COMMODORE JOHN RODGERS ELEMENTARY/MIDDLE SCHOOL

December 7, 2023 | Design Meeting Questions & Answers

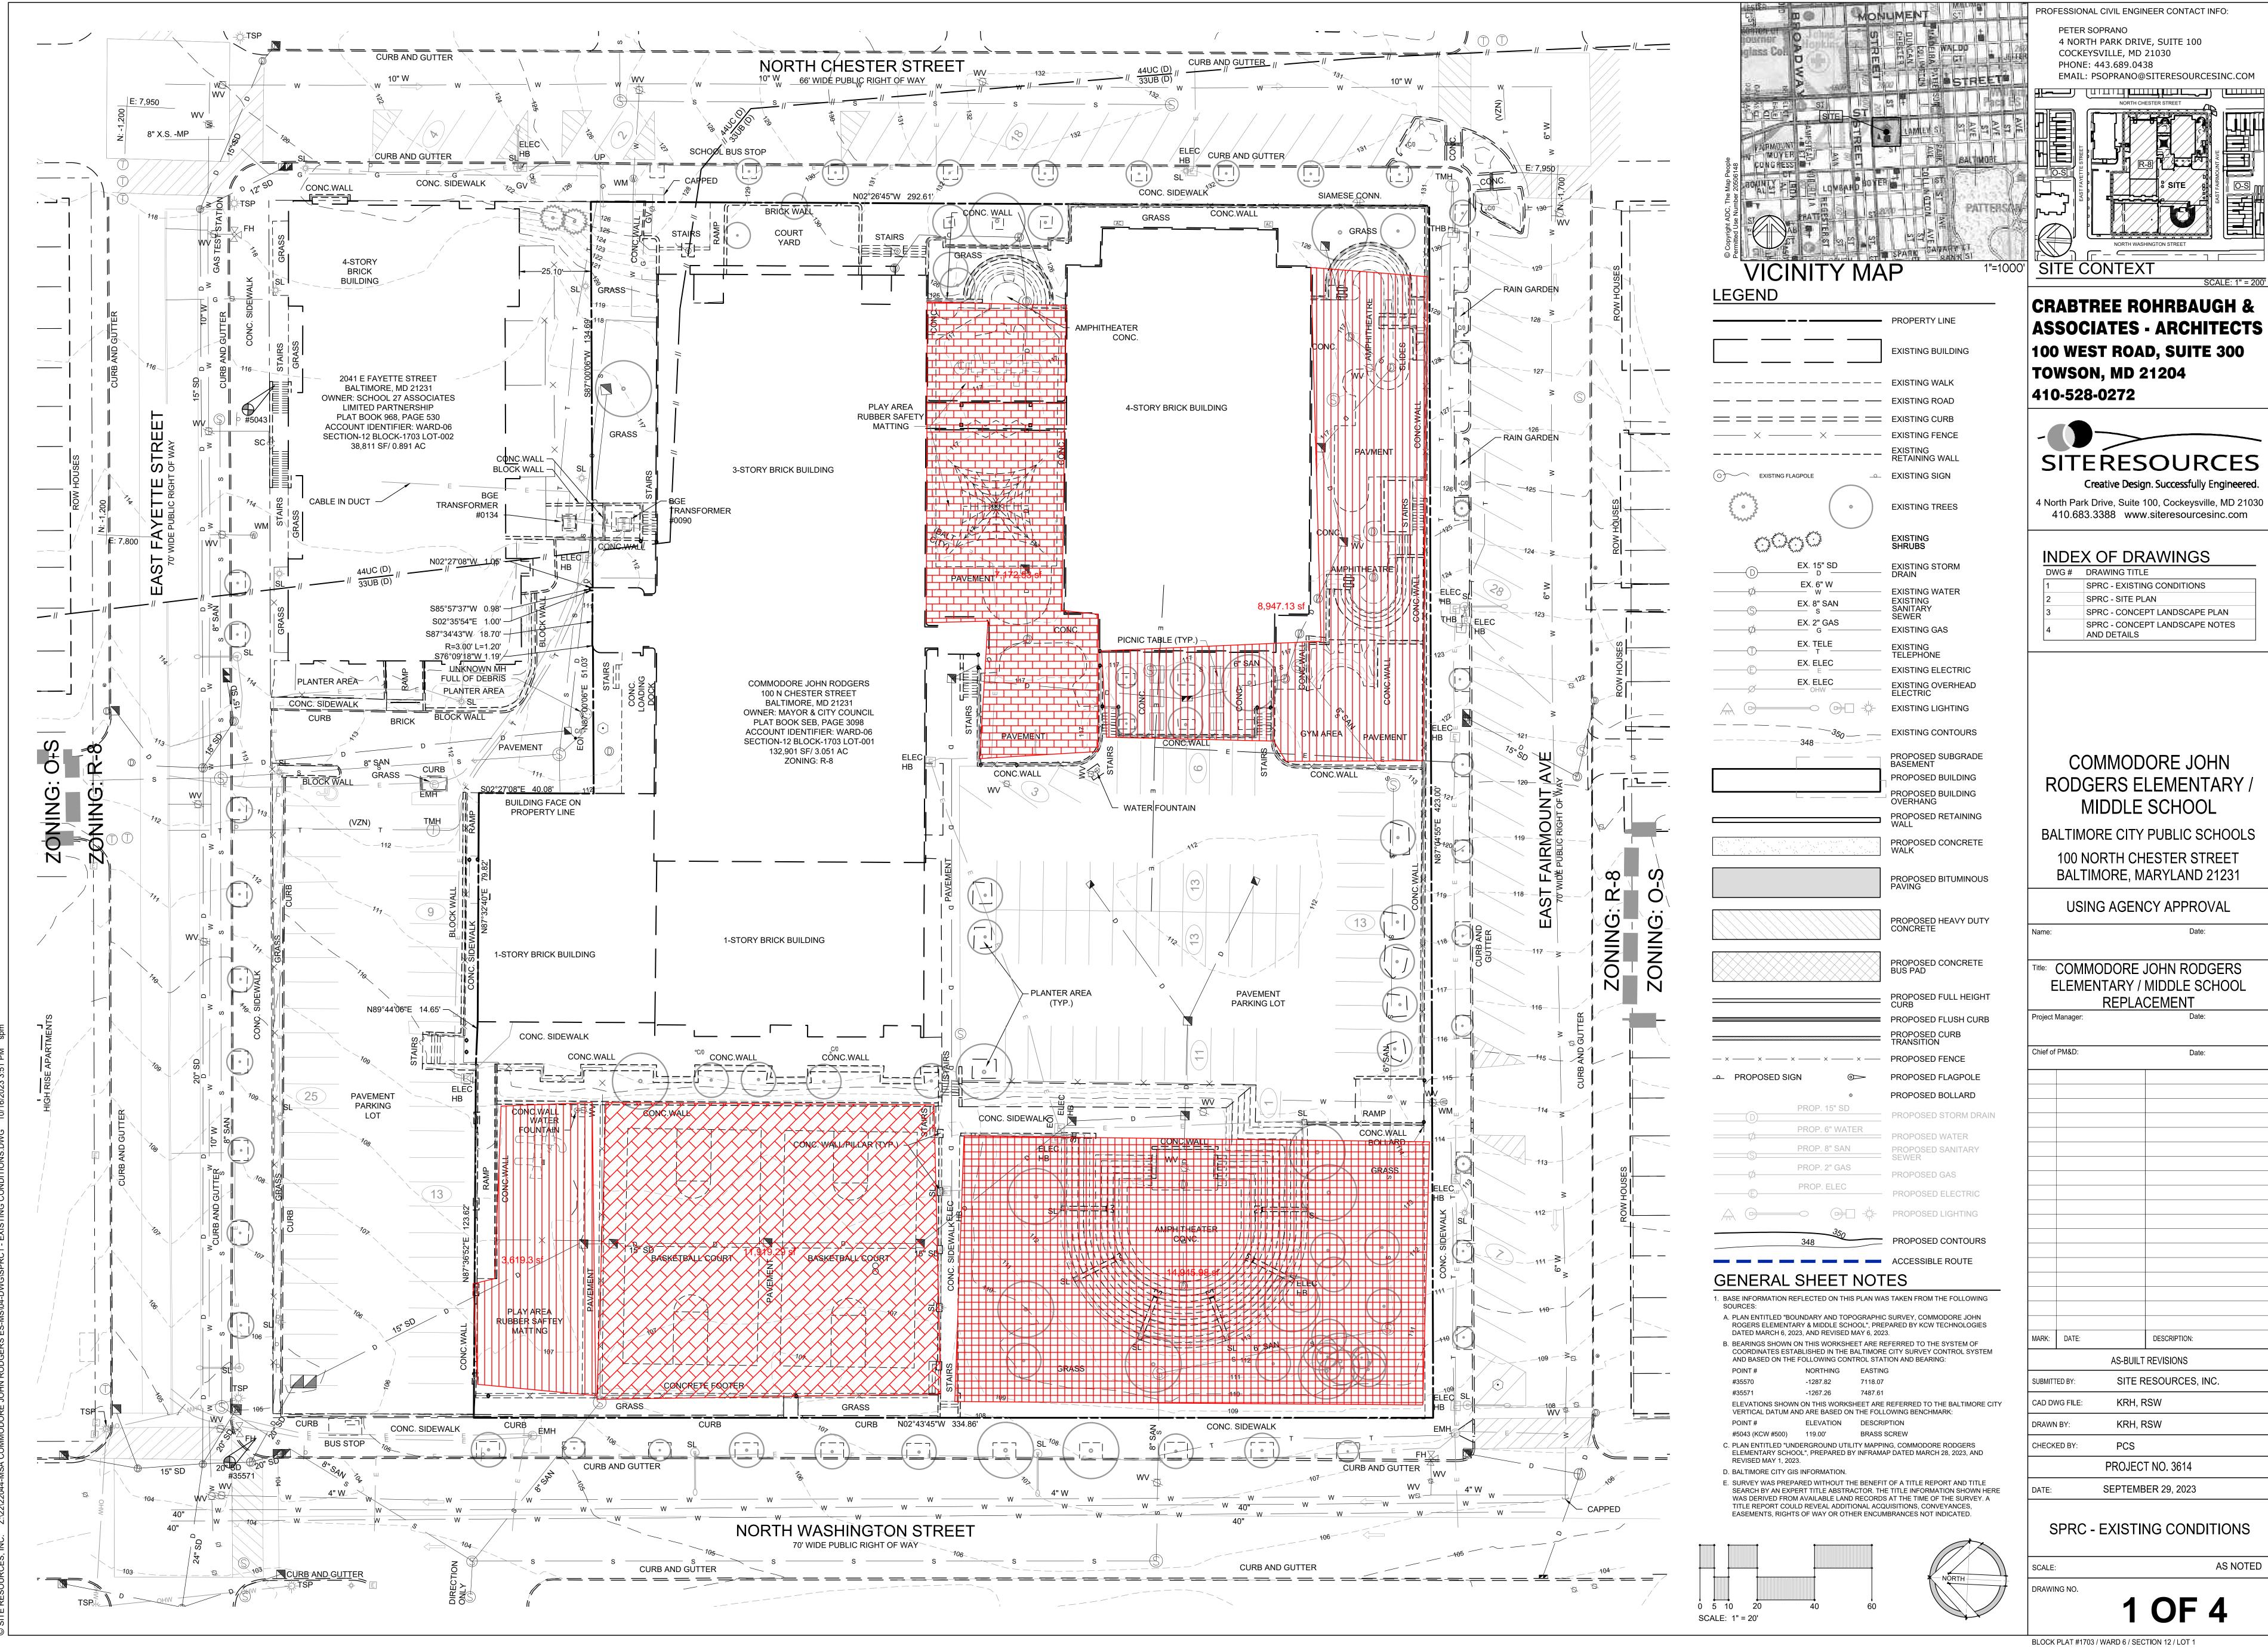
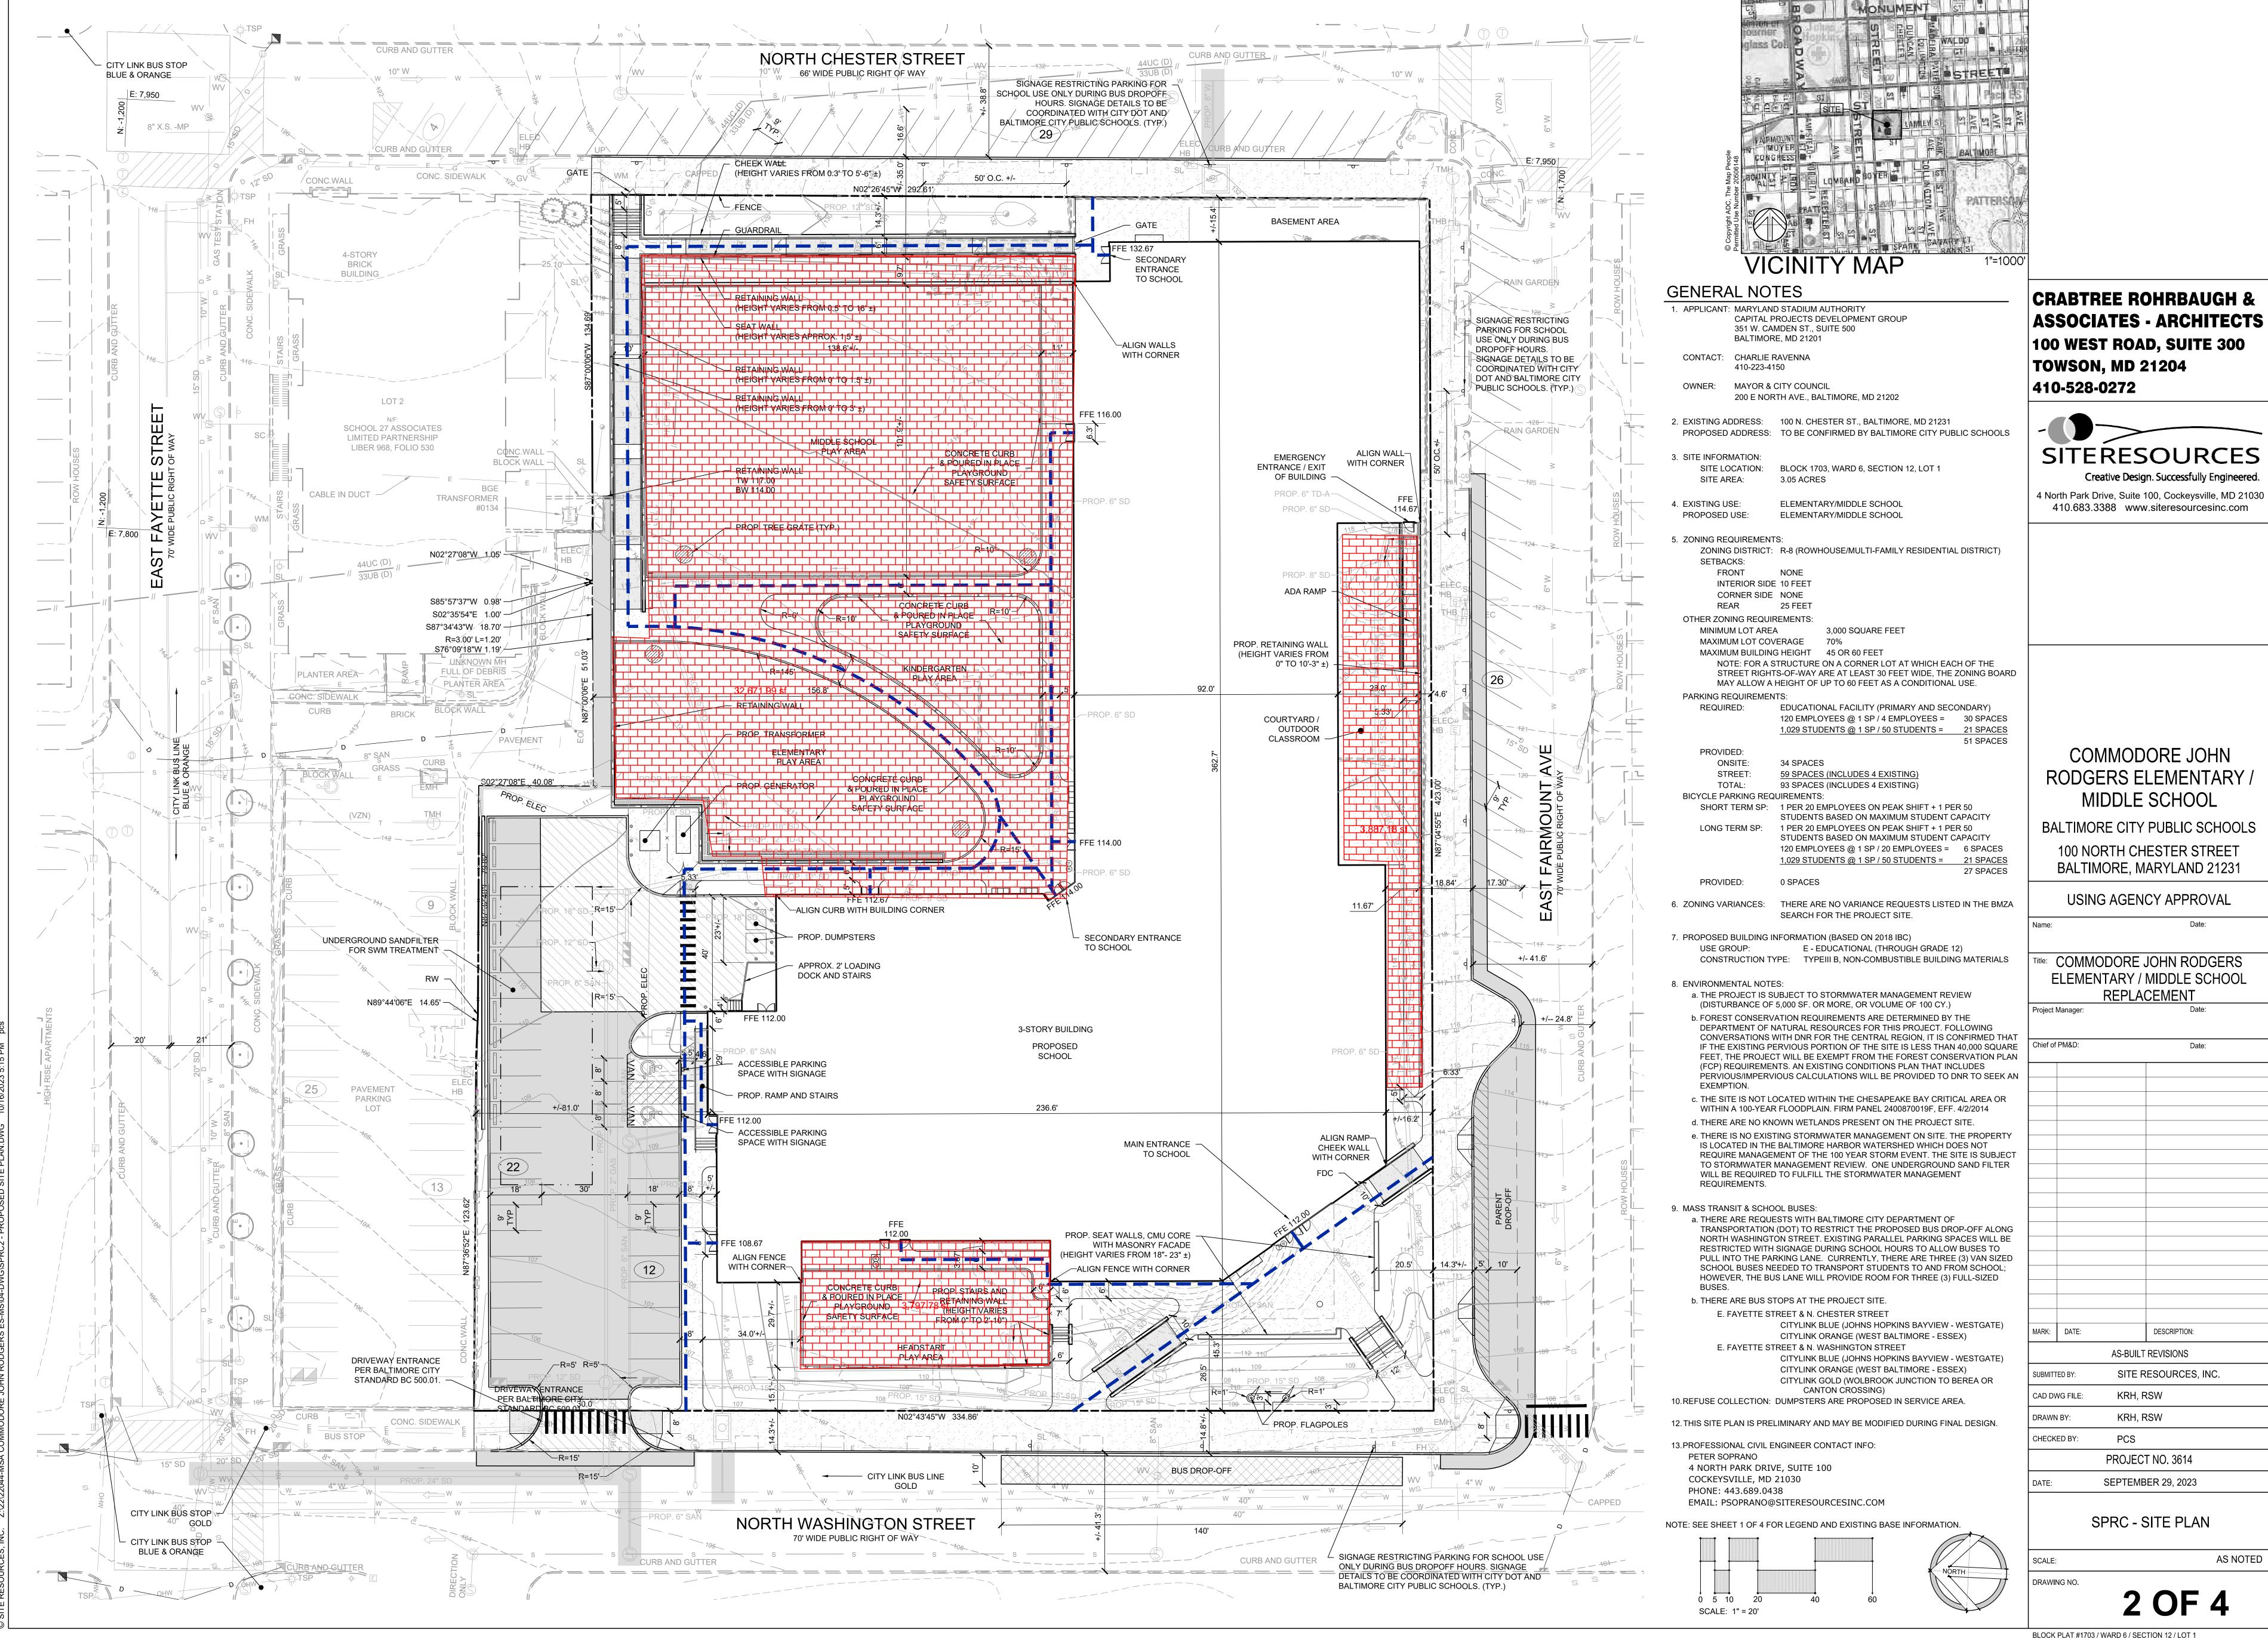
Q: How does the square footage of the proposed outdoor play spaces compare with the outdoor play spaces that the school is currently using (including spaces that may not have been designed or designated as official play spaces)?

A: The chart below is a quick study of the play areas.

View the next two pages for an in depth view of the play spaces.
